NG-15-0235
10 CFR 50.90

Duane Arnold Energy Center
Docket No. 50-331
Renewed Facility Operating License No. DPR-49

License Amendment Request (TSCR-144) to Revise and Relocate Pressure and Temperature Limit Curves to a Pressure and Temperature Limits Report

**PROPOSED TECHNICAL SPECIFICATIONS CHANGES
(MARKUP COPY)**

Figure 3.4.9-1 (page 1 of 1)

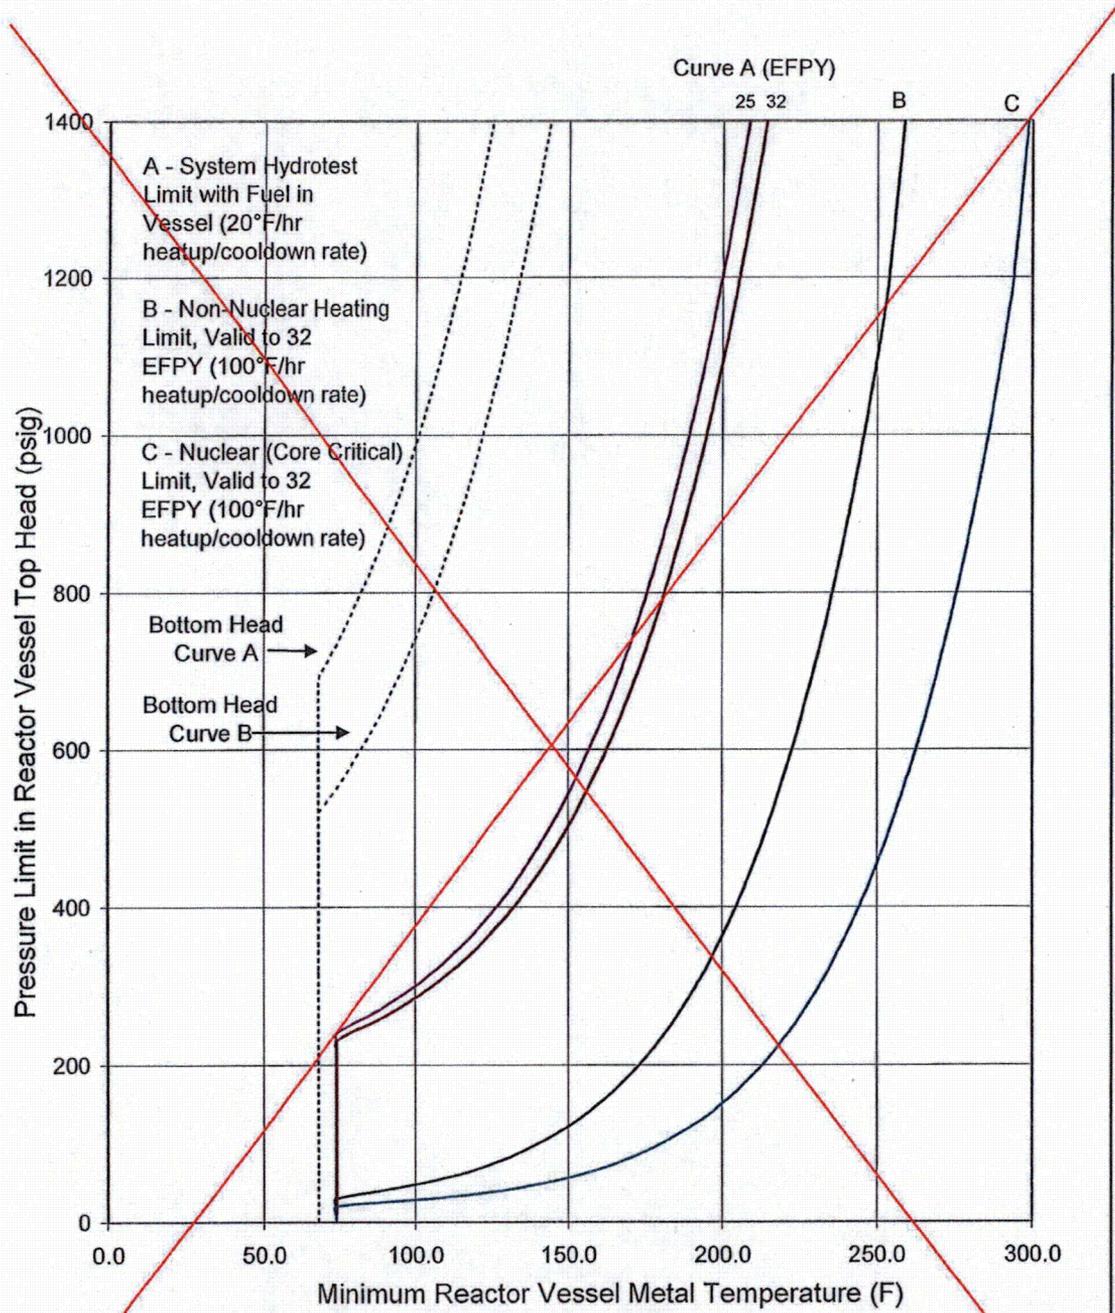
LCO 3.4.9 RCS pressure, RCS temperature, RCS heatup and cooldown rates, and the recirculation pump starting temperature requirements shall be maintained within ~~limits~~.

SURVEILLANCE	FREQUENCY
<p>SR 3.4.9.2 Verify RCS pressure and RCS temperature are within the criticality limits specified in Figure 3.4.9-1.</p> <p style="text-align: center;">the PTLR.</p>	<p>Once within 15 minutes prior to control rod withdrawal for the purpose of achieving criticality</p>
<p>SR 3.4.9.3 -----NOTE-----</p> <p>Only required to be met in MODES 1, 2, 3, and 4 during recirculation pump startup.</p> <p>-----</p> <p>Verify the difference between the bottom head coolant temperature and the Reactor Pressure Vessel (RPV) coolant temperature is \leq 145°F.</p> <p style="text-align: center;">within the limits specified in the PTLR</p>	<p>Once within 15 minutes prior to each startup of a recirculation pump</p>
<p>SR 3.4.9.4 -----NOTE-----</p> <p>Only required to be met in MODES 1, 2, 3, and 4 during recirculation pump startup.</p> <p>-----</p> <p>Verify the difference between the reactor coolant temperature in the recirculation loop to be started and the RPV coolant temperature is \leq 50°F.</p> <p style="text-align: center;">within the limits specified in the PTLR</p>	<p>Once within 15 minutes prior to each startup of a recirculation pump</p>

→ ~~Figure 3.4.9-1~~ contains P/T limit curves for heatup, cooldown, and inservice leakage and hydrostatic testing, and data for the maximum rate of change of reactor coolant temperature. The heatup curve provides limits for both heatup and criticality.

- a. ~~RCS pressure and temperatures are within the limits of the applicable curves of Figure 3.4.9-1 and heatup or cooldown rates are $\leq 100^\circ\text{F/hr}$ during RCS heatup and cooldown, and $\leq 20^\circ\text{F/hr}$ during pressure testing (e.g., hydrostatic testing). Note: The P/T limits and corresponding heatup/cooldown rates of either Curve A or B may be applied while achieving or recovering from test conditions. Curve A applies during pressure testing and when the limits of Curve B cannot be maintained;~~

- d. ~~RCS pressure and temperature are within the criticality limits specified in Figure 3.4.9-1 prior to achieving criticality; and~~ the PTLR,
- e. The temperatures at the reactor vessel head flange and the shell adjacent to the head flange are $\geq 74^\circ\text{F}$ when tensioning the reactor vessel head bolting studs.

the limits specified in the PTLR

SURVEILLANCE		FREQUENCY
SR 3.4.9.2	Verify RCS pressure and RCS temperature are within the criticality limits specified in the PTLR.	Once within 15 minutes prior to control rod withdrawal for the purpose of achieving criticality
SR 3.4.9.3	<p>-----NOTE----- Only required to be met in MODES 1, 2, 3, and 4 during recirculation pump startup. -----</p> <p>Verify the difference between the bottom head coolant temperature and the Reactor Pressure Vessel (RPV) coolant temperature is within the limits specified in the PTLR.</p>	Once within 15 minutes prior to each startup of a recirculation pump
SR 3.4.9.4	<p>-----NOTE----- Only required to be met in MODES 1, 2, 3, and 4 during recirculation pump startup. -----</p> <p>Verify the difference between the reactor coolant temperature in the recirculation loop to be started and the RPV coolant temperature is within the limits specified in the PTLR.</p>	Once within 15 minutes prior to each startup of a recirculation pump
